SUBJECT: DONALD C. COOK NUCLEAR PLANT, UNITS 1 AND 2 – STAFF
ASSESSMENT OF RESPONSE TO 10 CFR 50.54(f) INFORMATION REQUEST
– FLOOD-CAUSING MECHANISM REEVALUATION (CAC NOS. MF6096 AND
MF6097)

STAFF ASSESSMENT BY THE OFFICE OF NUCLEAR REACTOR REGULATION

RELATED TO FLOODING HAZARD REEVALUATION REPORT

DONALD C. COOK NUCLEAR PLANT, UNITS 1 AND 2

Figure 3.2-1 – D.C. Cook site critical monitoring locations selected for LIP flood analysis (from D.C. Cook FHRR, Figure 3-4 (IMP, 2015b))

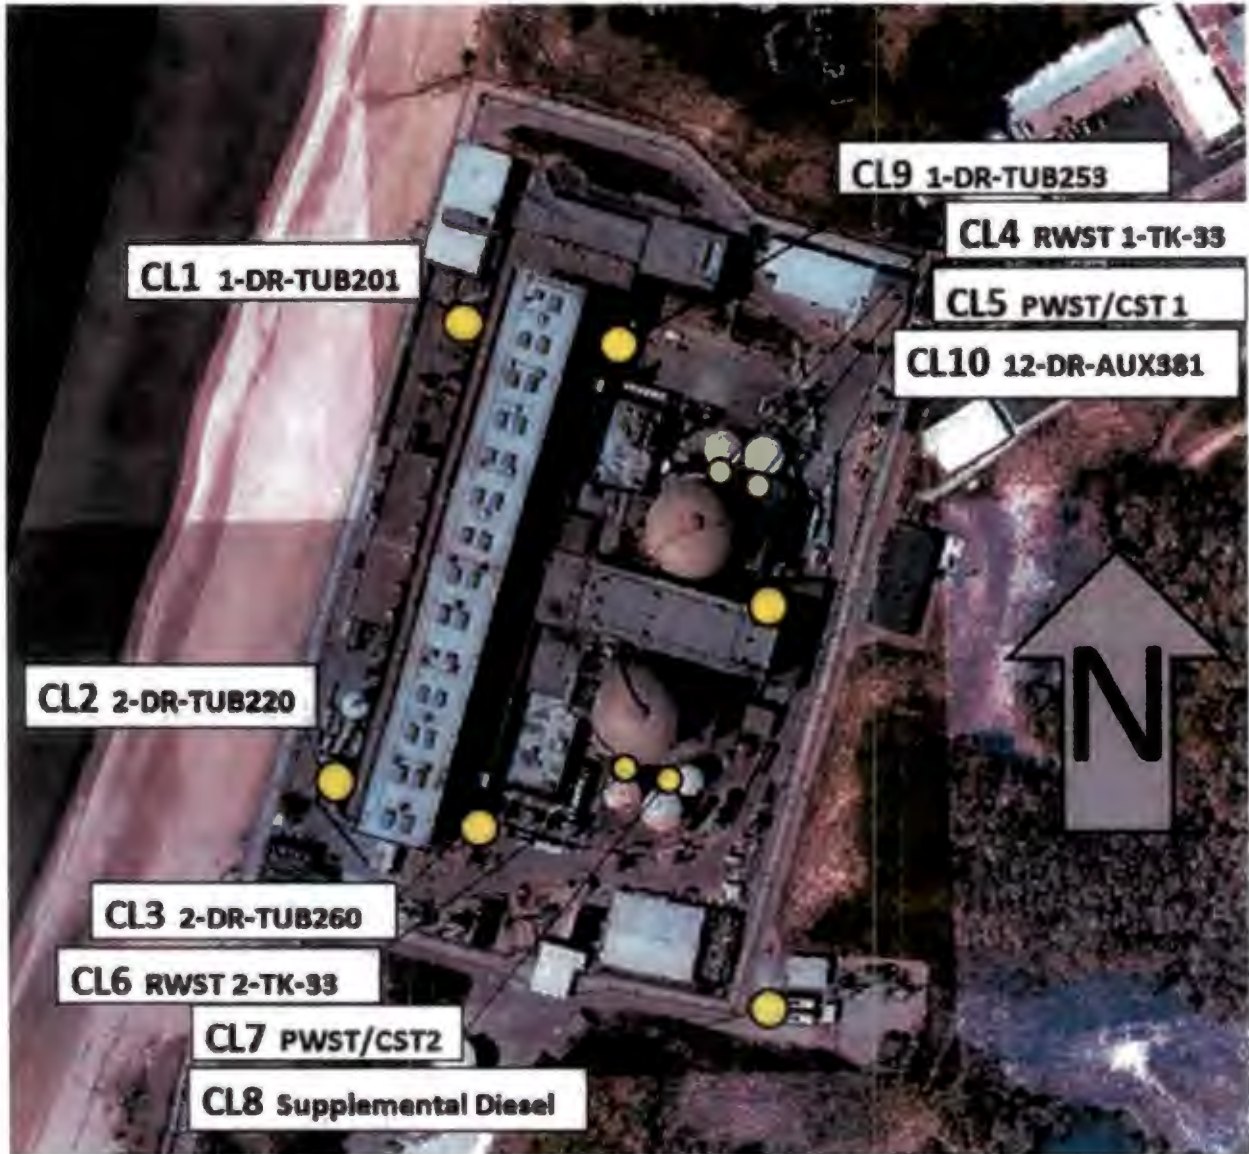
The licensee identified, based on general site and plant configuration and plant walkdown, 10 critical area locations where LIP runoff could impact SSCs important to safety of the plant as shown on Figure 3.2-1. These 10 locations are identified to be locations of potential SSC vulnerability where predicted flood elevations exceed surveyed threshold elevations and have the potential to produce adverse conditions. Additional realistic or conservative assumptions used in the LIP modeling are:

The NRC staff reviewed details of the licensee's FLO-2D model implementation and determined that the approaches and assumptions were conservative and appropriate. The model output files reviewed by NRC staff did not report any errors related to model stability or mass balance. Based on a confirmatory run of the licensee-provided FLO-2D model, the NRC staff determined that the licensee's conclusions, based on results produced by the model, are reasonable.
